From: Ian Stocks [REDACTED] **On Behalf Of** FRS Water and Access
Sent: 08 June 2021 16:53
To: Planning.Responses <Planning.Responses@arun.gov.uk>
Subject: Hydrant condition - AL/50/21/PL L'Apache Westergate Street Woodgate PO20 3SQ

HYDRANT CONDITION CONSULTATION WITH PLANNING AUTHORITY

Planning Ref: AL/50/21/PL

Description: Variation following grant of AL/103/18/PL to amend Condition No 2 approved plans - to change the design & layout of approved 2 No. dwellings.

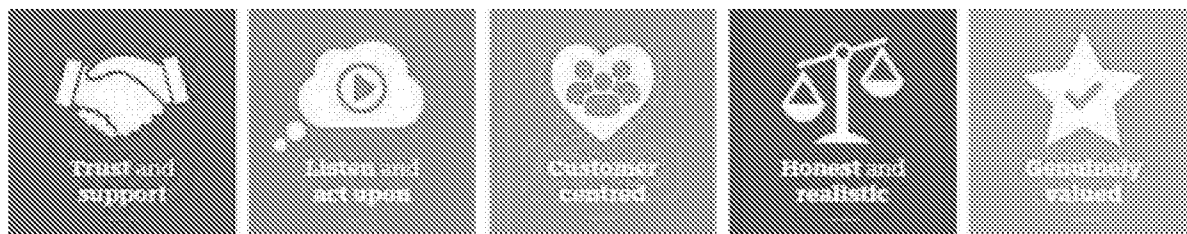
Please find attached a planning condition for application no. AL/50/21/PL for the requirement of an additional fire hydrant. Currently the nearest Hydrant to these proposed properties is 400 metres away. The supply of water for firefighting for a domestic premises should be within 175 metres.

Evidence will also be required that Fire Service vehicle access meets with the requirements identified in Approved Document B Volume 1 2019 Edition: B5 Section 13, including Table 13.1 and diagram 13.1. The plan submitted indicates the access route is too narrow for a Fire Appliance to gain access and also insufficient turning facility for a Fire Appliance to turn and make an exit.

- 1) Prior to the commencement of the development details showing the proposed location of [1] one fire hydrant or stored water supply (in accordance with the West Sussex Fire and Rescue Guidance Notes) shall be submitted to and approved in writing by the Local Planning Authority in consultation with West Sussex County Council's Fire and Rescue Service. These approvals shall not be unreasonably withheld or delayed.
- 2) Prior to the first occupation of any dwelling/unit forming part of the proposed development that they will at their own expense install the fire hydrant in the approved location to BS 750 standards or stored water supply and arrange for their connection to a water supply which is appropriate in terms of both pressure and volume for the purposes of firefighting.
